Sundry Print Report

Well Name: SHANGHAI ROOSTER 22- Well Location: T25S / R29E / SEC 15 / County or Parish/State:

**Sundry ID: 2701040**

Type of Action: APD Change

#### WELL LOCATION AND ACREAGE DEDICATION PLAT

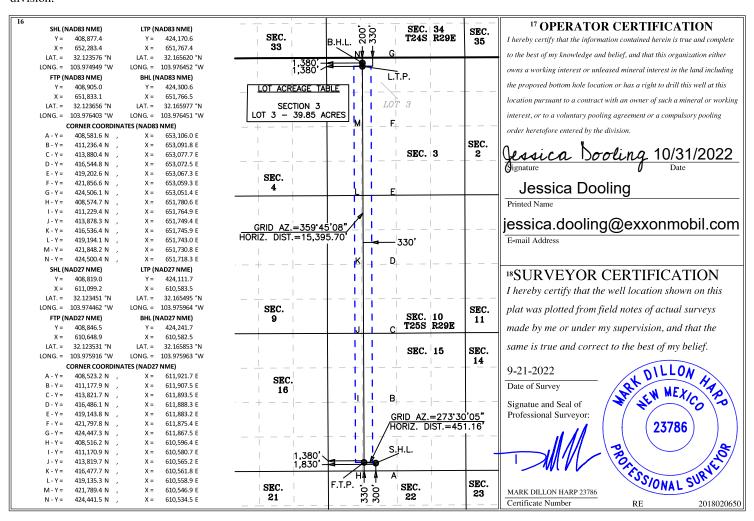
Procedure Description: \*\*Well Name and Number Change, Pool Change, Surface Hole Location Change, Bottom Hole Location Change, First and Last Take Point Changes XTO Energy, Inc. requests permission to make the following changes to the original APD: Change Well Name from Shanghai Rooster 22-27 Fed to Shanghai Rooster 15-3 Fed Change Well Number from 703H to 802H Change Pool from 96217 Willow Lake; Bone Spring, Southeast to 98220 Purple Sage; Wolfcamp Change SHL fr/295'FSL & 1855'FWL to 300' FSL & 1830' FWL, Section 15-T25S-R29E No Additional Surface Disturbance Change BHL fr/200'FSL & 1656'FWL, Section 27-T25S-R29E to 200'FNL & 1380'FWL, Section 3-T25S-R29E Change FTP fr/330'FNL & 1656'FWL to 330'FSL & 1380'FWL Change LTP fr/330'FSL & 1656'FWL to 330'FNL & 1380'FWL Additionally, XTO Energy, Inc. respectfully requests permission to upsize the surface, intermediate and production hole, casing and cement based on the attached drilling program. Due to the upsize in these strings, the wellhead configuration has also changed based on the attached drilling program. Attachments: C102 Drilling Program MBS Diagram Directional Plan
